January 8, 2020

ADDENDUM NUMBER THREE (3)

Project: Replacement Facility for
Tippah County Hospital
Ripley, MS
PN: 18015

FROM: Dean and Dean/Associates Architects, P.A.
4400 Old Canton Road, Suite 200
Jackson, MS 39211
(601) 939-7717

Sheet Number: P201.6 - ENLARGED MEDICAL GAS PLAN - PART "6"

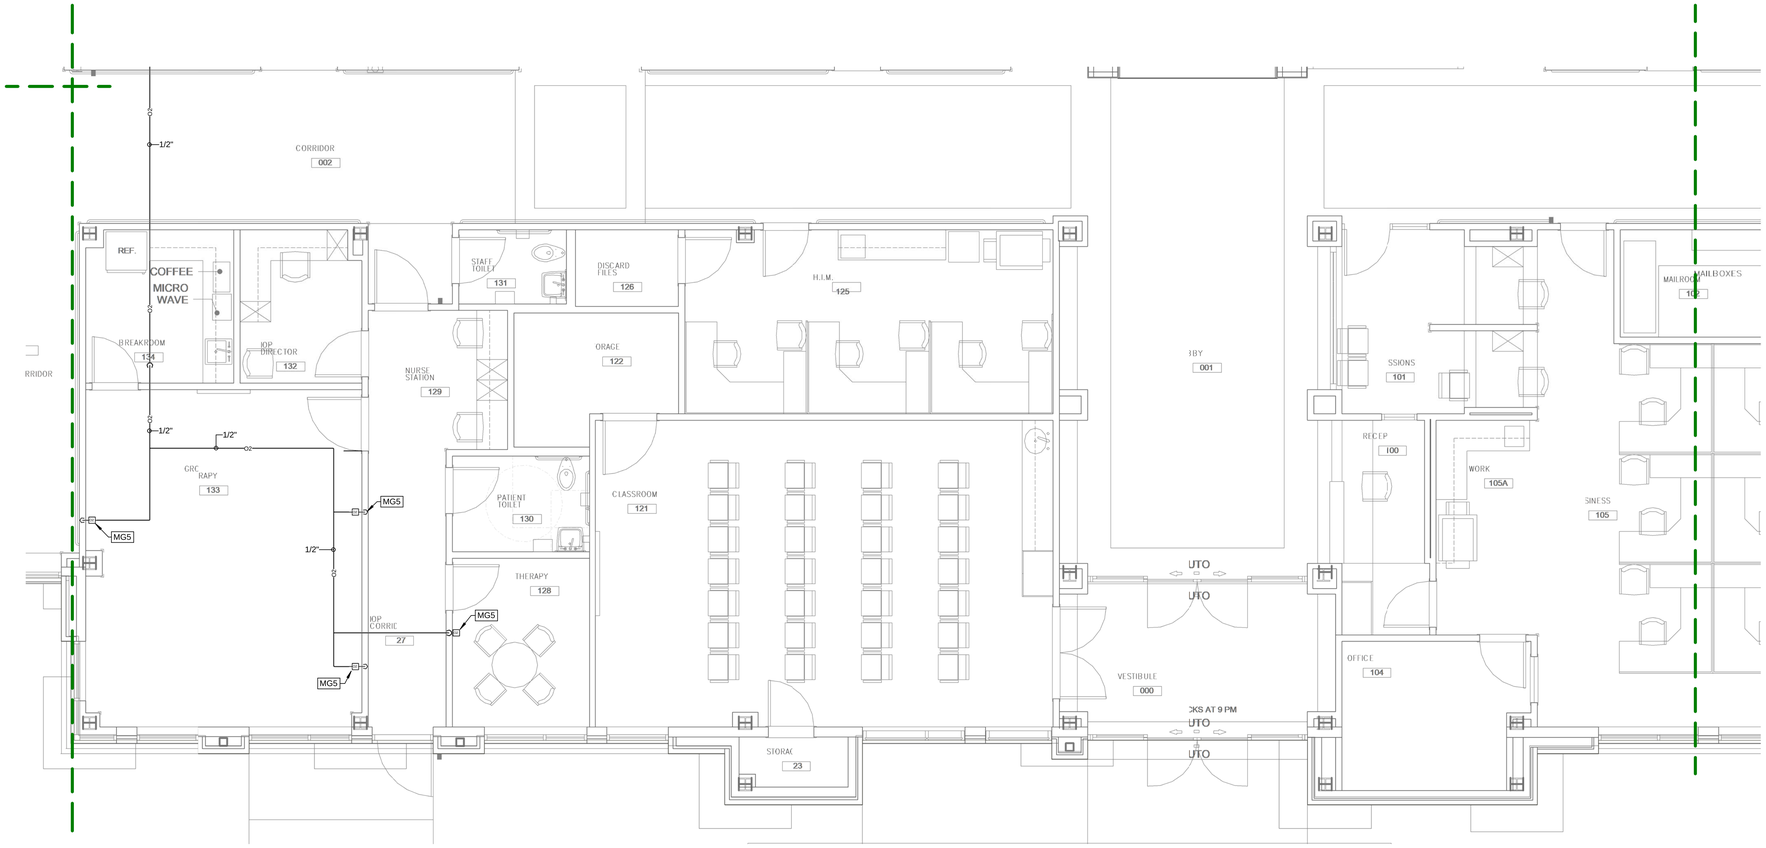
5. Sheet P201.6 – Enlarged Medical Gas Plan – Part "6". Add new sheet P201.6 (attached). Added additional oxygen piping and wall outlets.

1 SITE PLAN - ELECTRICAL
E101 SCALE: 1"=30'-0"

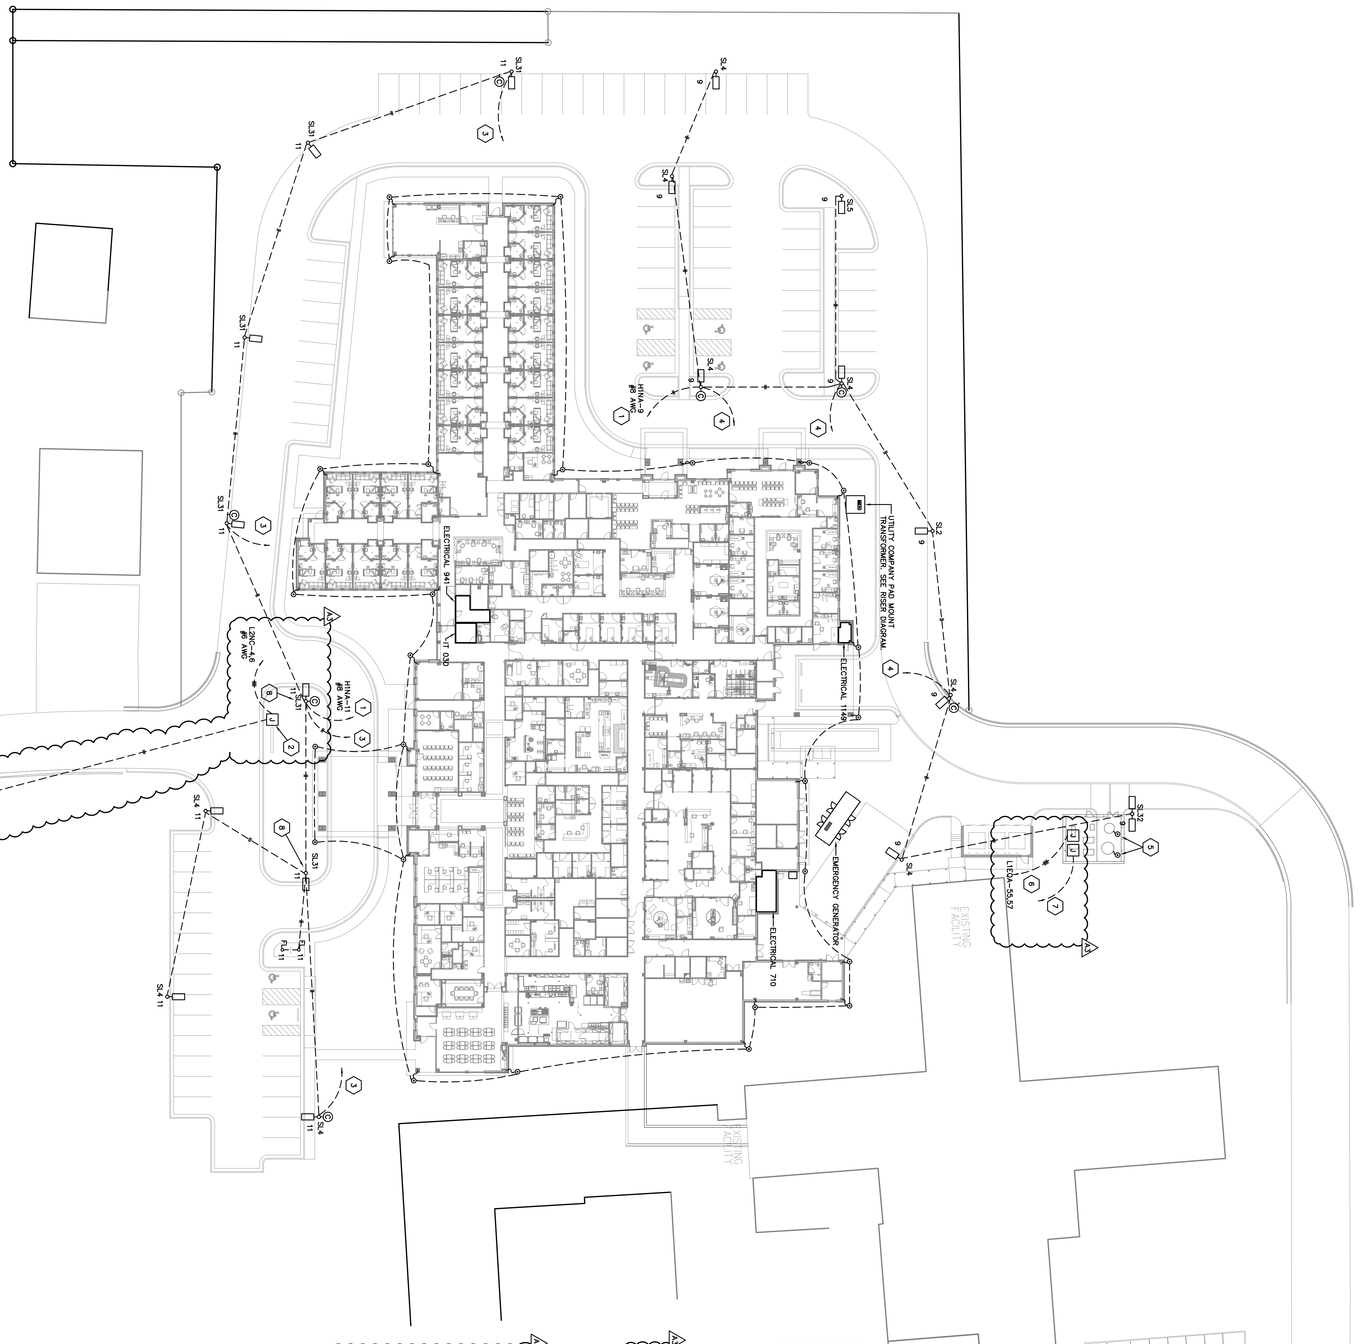
1. Electrical requirements have been added to the Oxygen Storage Yard.
2. The existing sign in front of the existing hospital shall be relocated to the new Entrance Drive.
3. A new internally illuminated sign has been added to the site.
4. Two pole lights (Type SL31) at the front entry shall have 3" tall base, above finished grade. Poles shall be 28' in height.

1 PARTIAL FLOOR PLAN – LIGHTING PART A
E201A SCALE: 1/8"=1'-0"

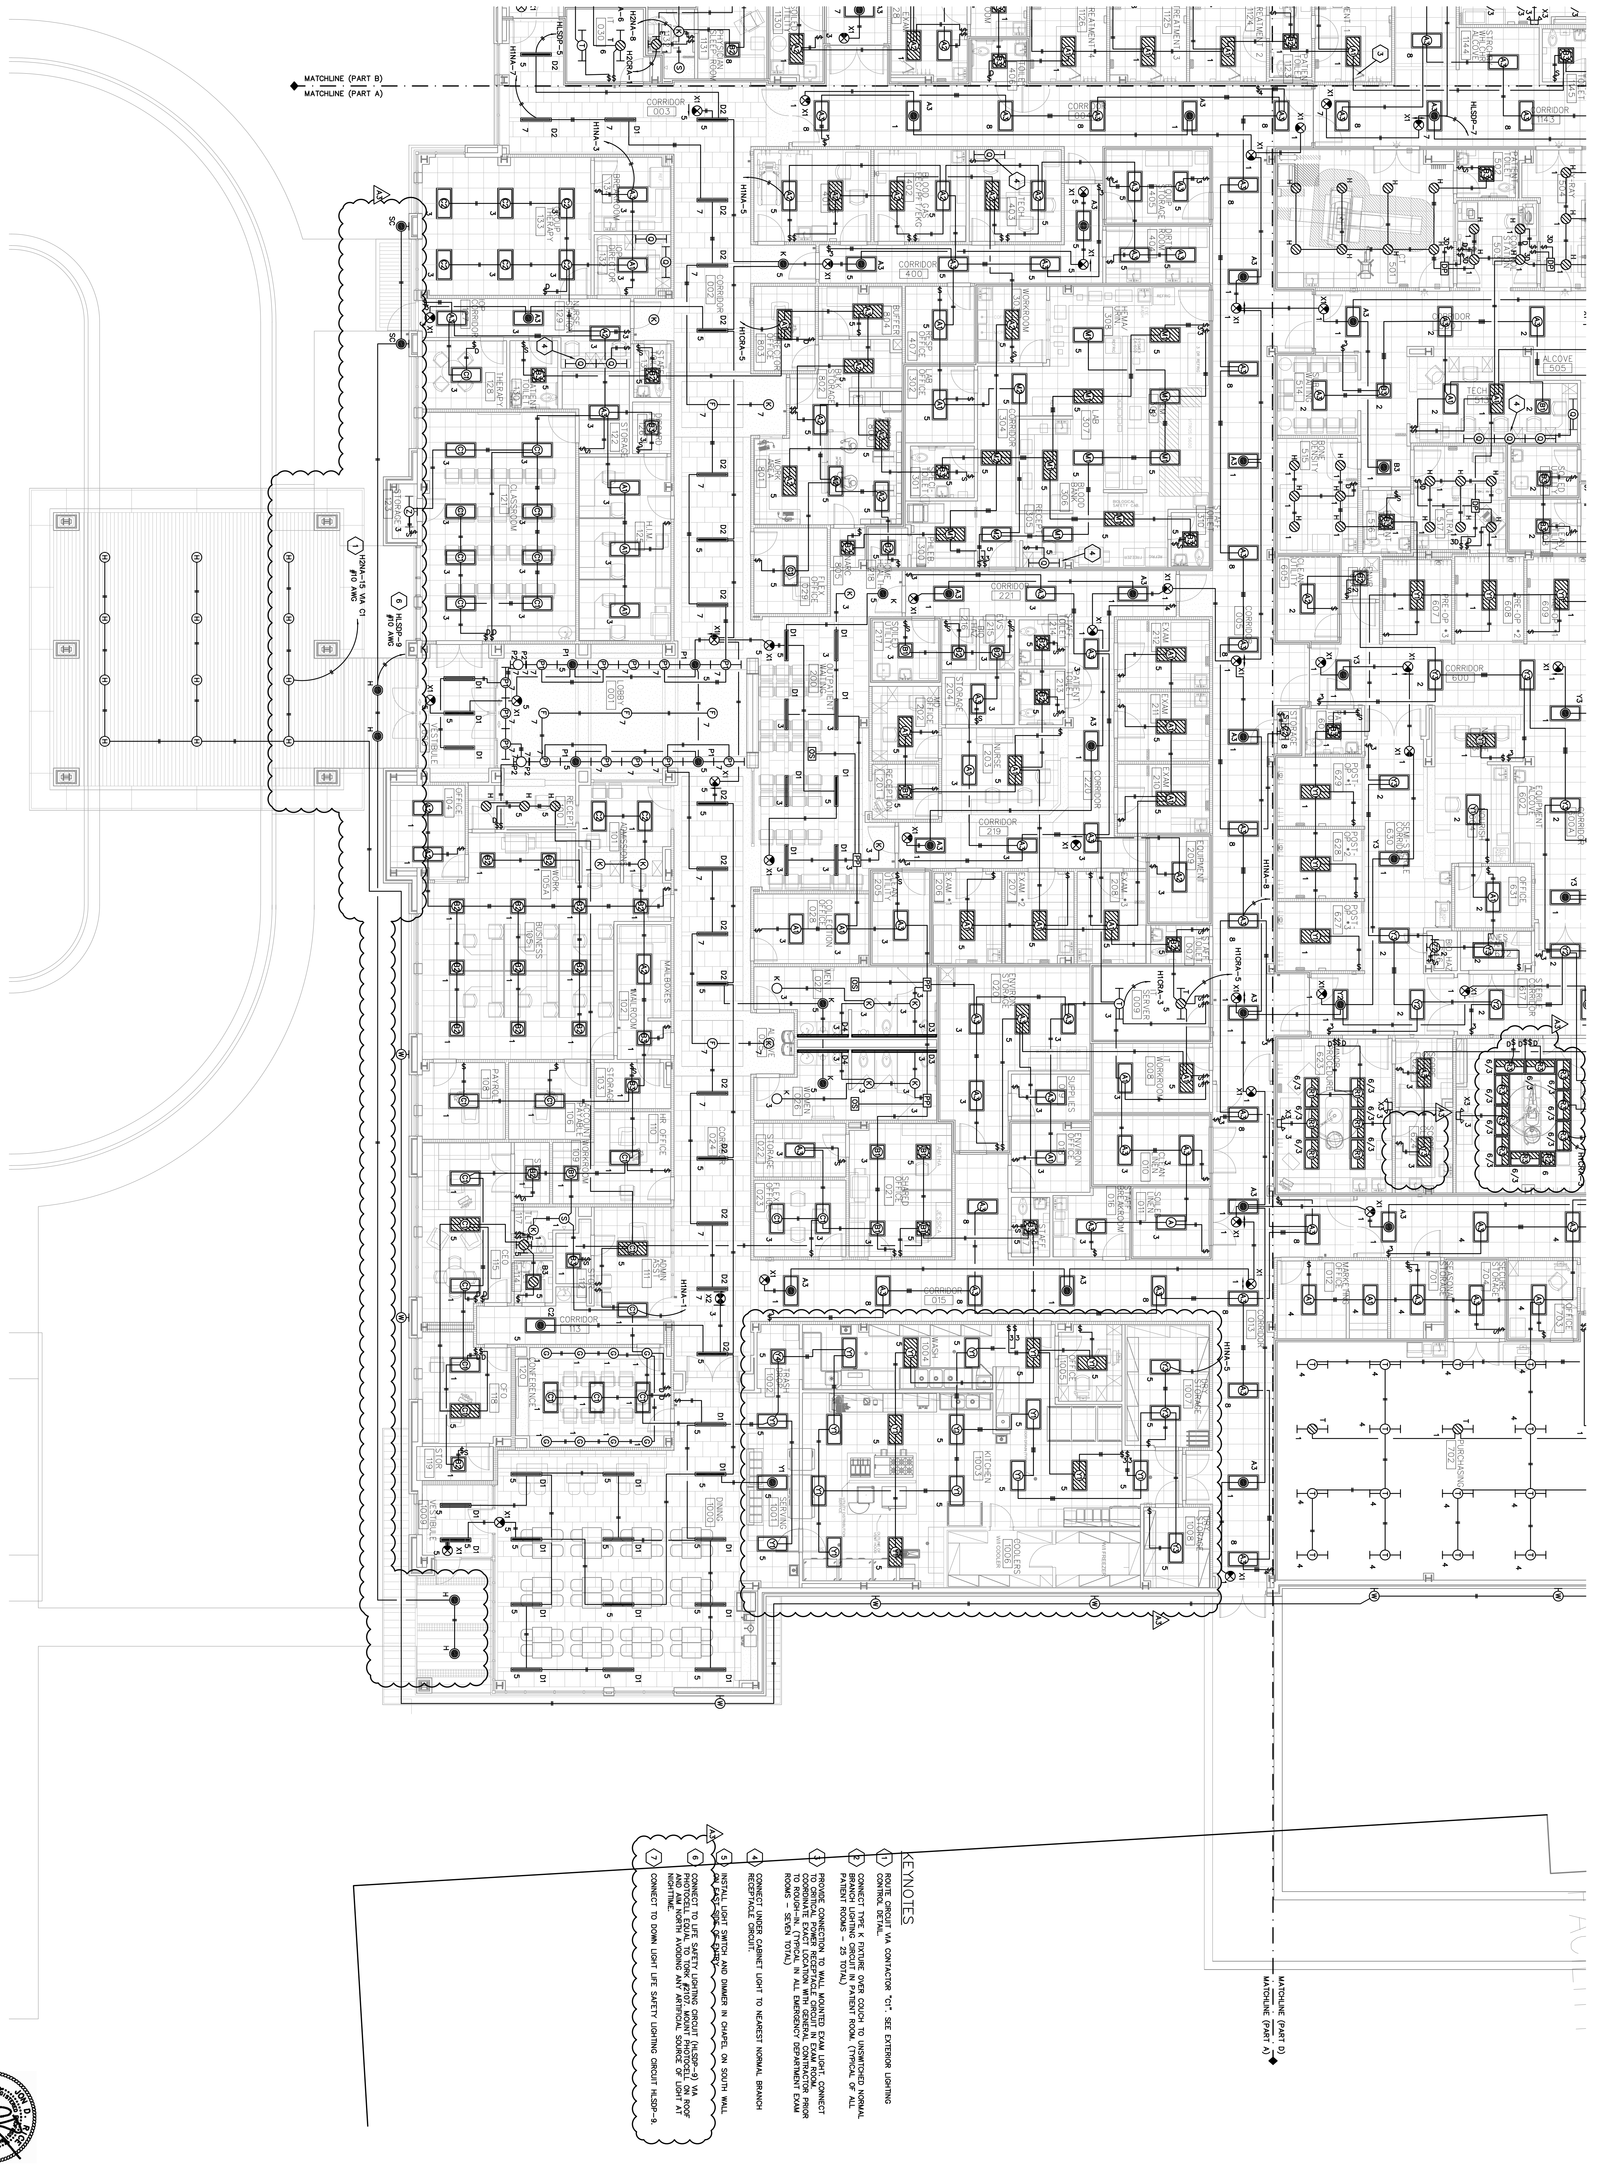
1. The Type "A" lights in the Kitchen area shall be type "Y" light fixtures.
2. The circuits to the canopy lighting and wall sconces on the East side of the facility have been modified to include emergency lighting.

1 PARTIAL FLOOR PLAN – LIGHTING PART C
E201C SCALE: 1/8"=1'-0"

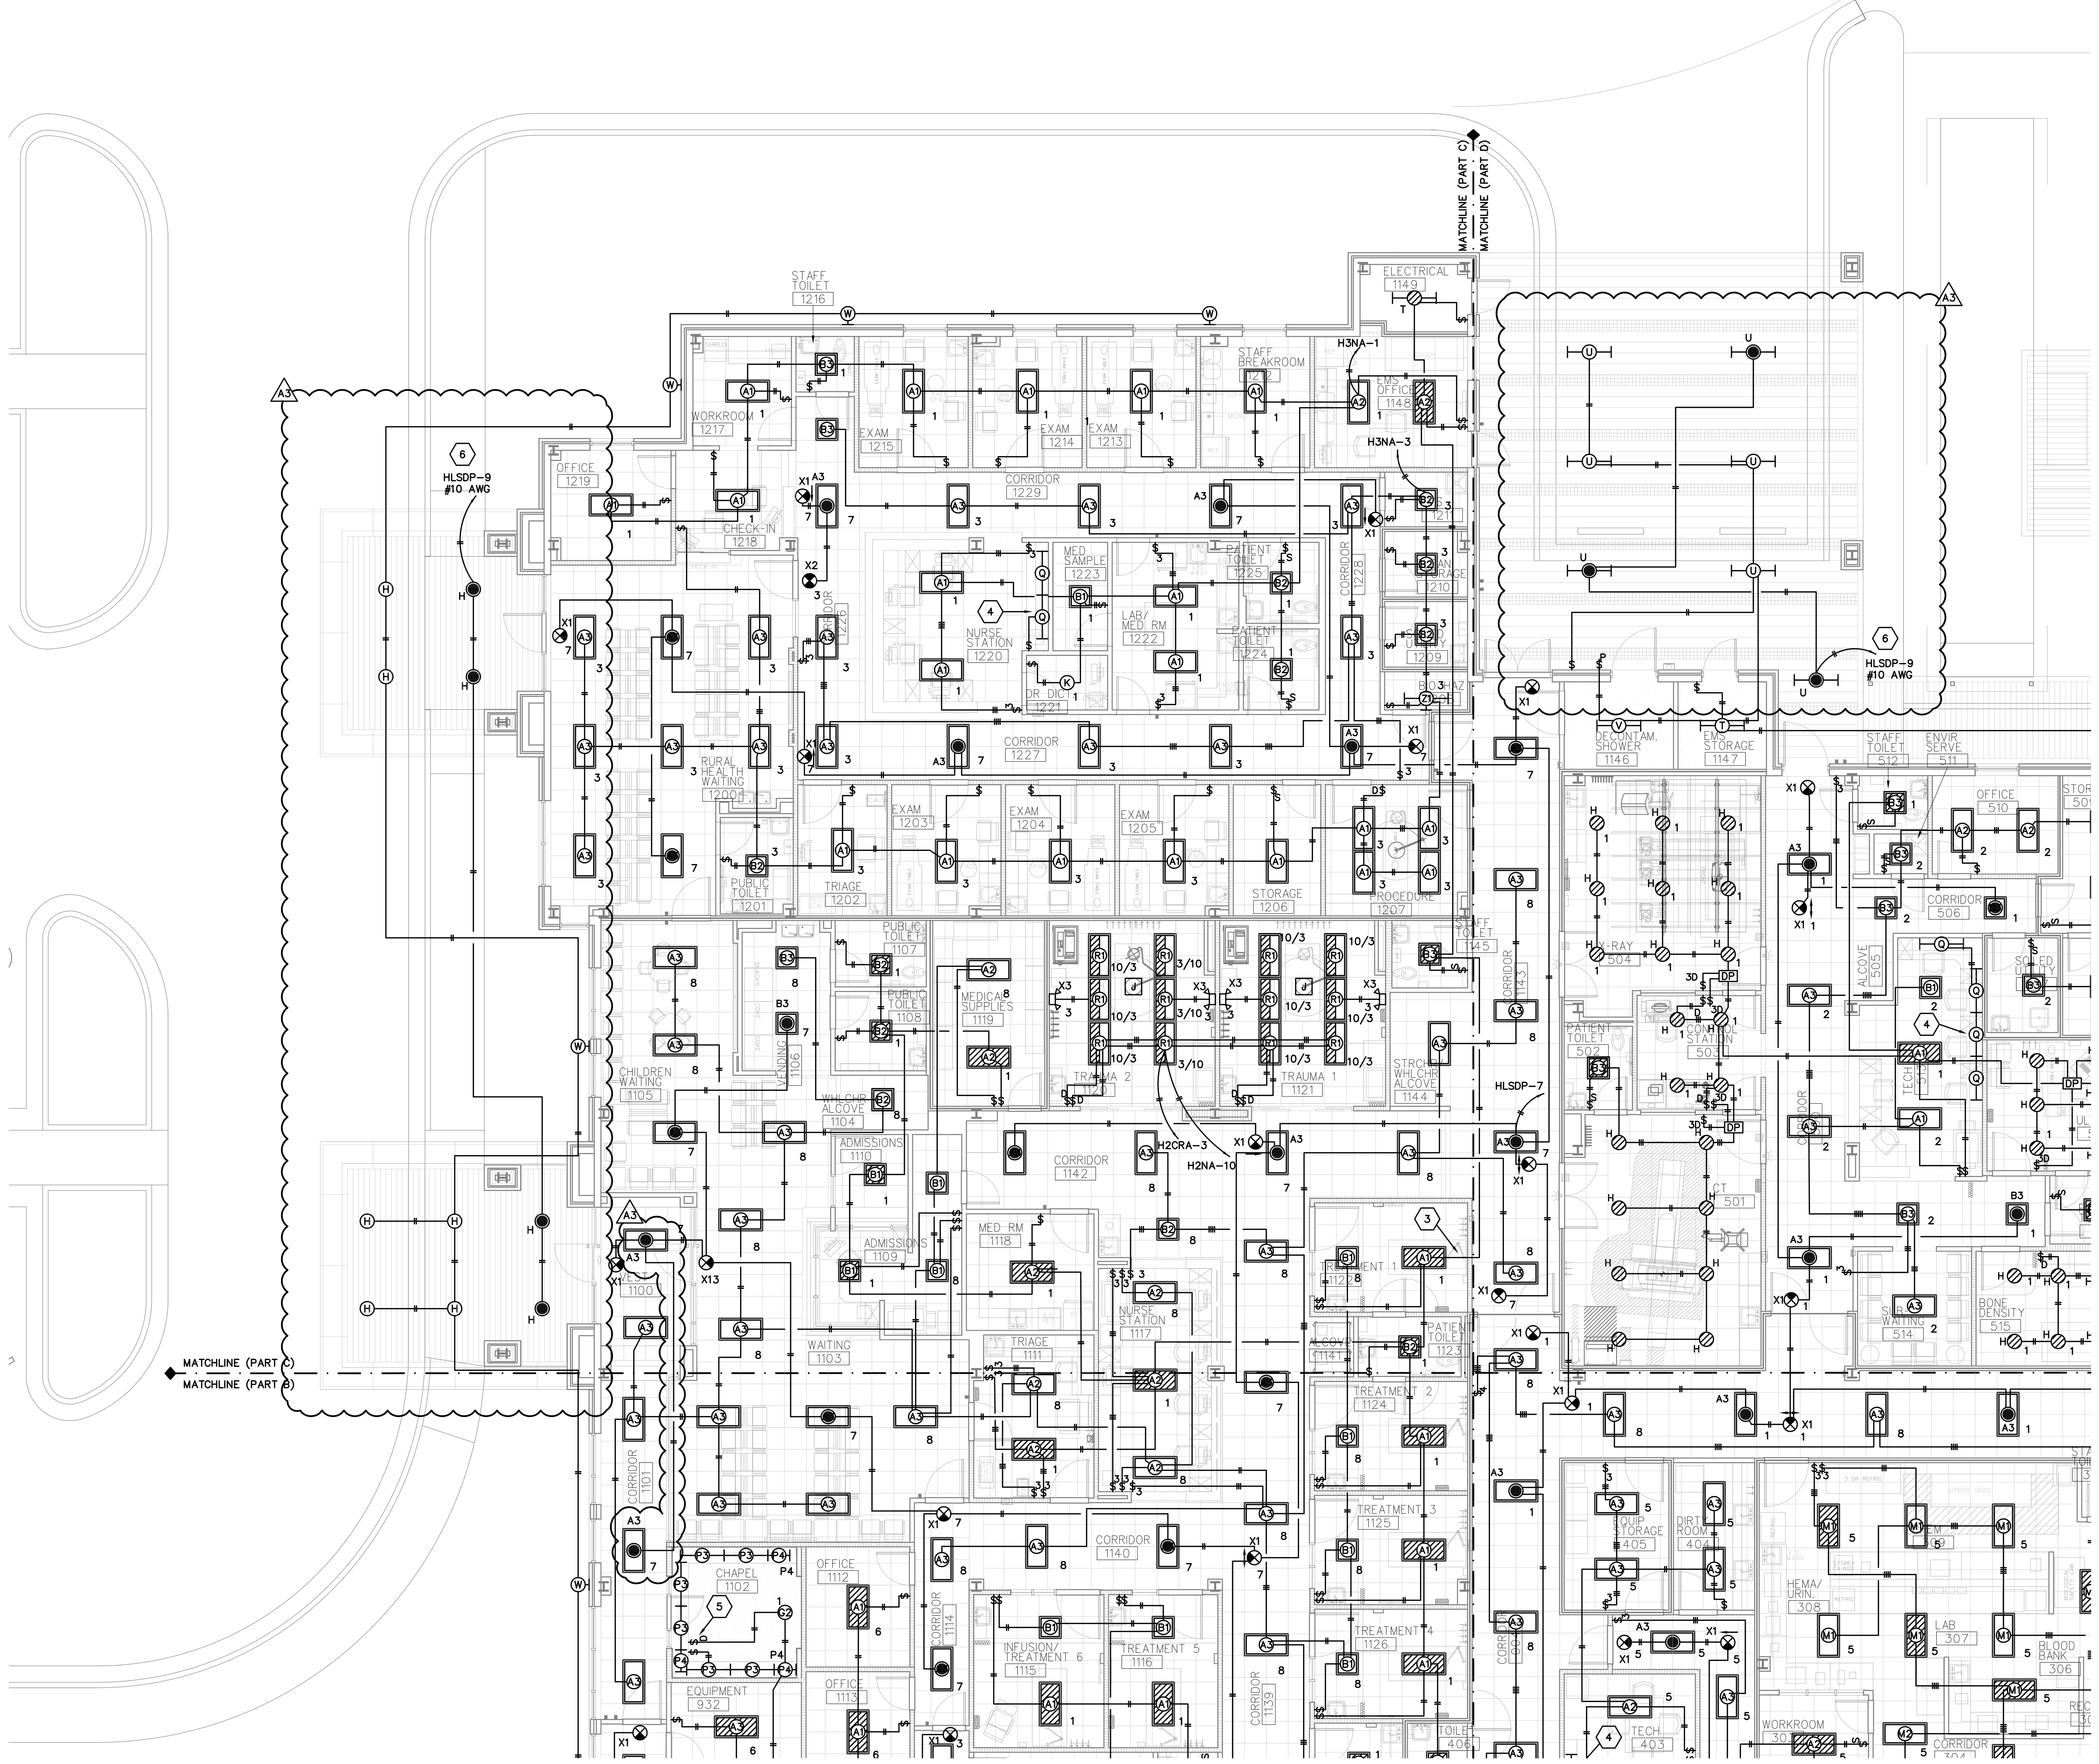
1. The circuits to the light fixtures at the Emergency Department, and Rural Health Clinic entrance canopies have been modified to include emergency lighting.
2. A life safety circuit has been added to a light in Corridor 1101.
